Change of geometry rail mount SLAS RF 15 OR 1665 (2093330000)

1. General Overview

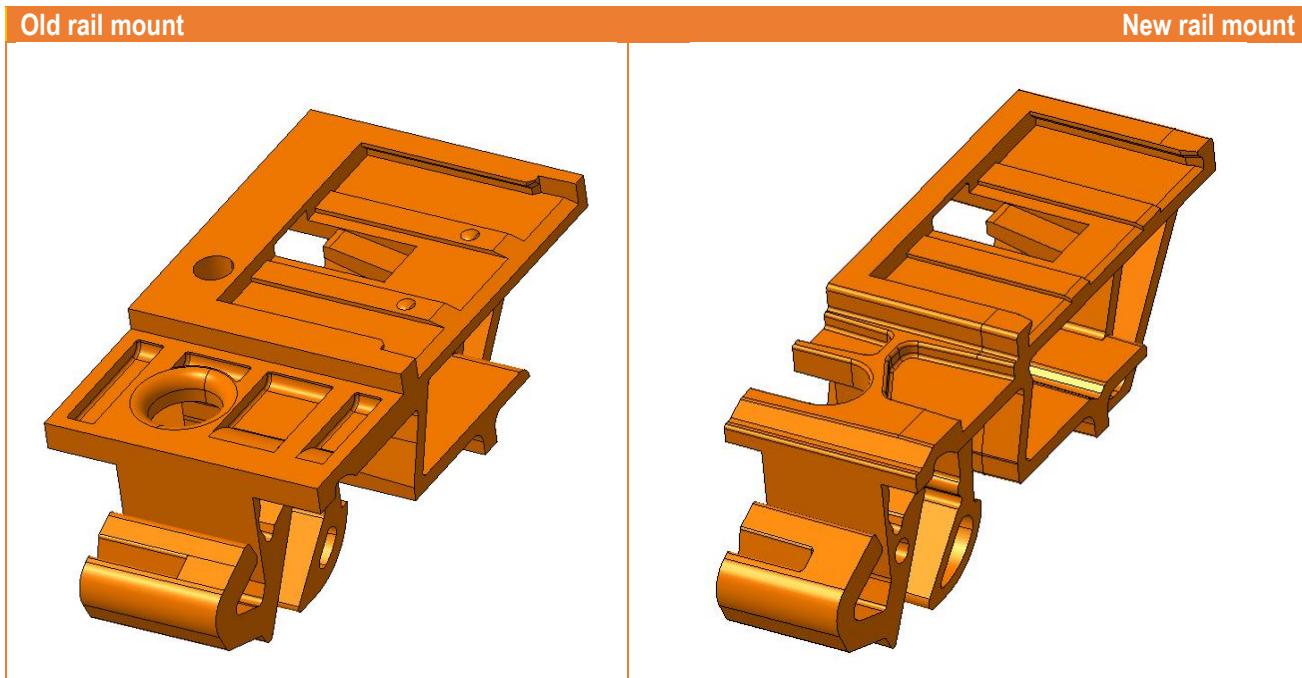
The product RASTFUSS SLAS RF 15 OR 1665 (2093330000) will be delivered in a different geometry. The width of the rail mount has been reduced from 20 mm to 12.8 mm. The change improves the ergonomic handling of the rail mount foot by easier mounting on the rail as well as on the connector side.
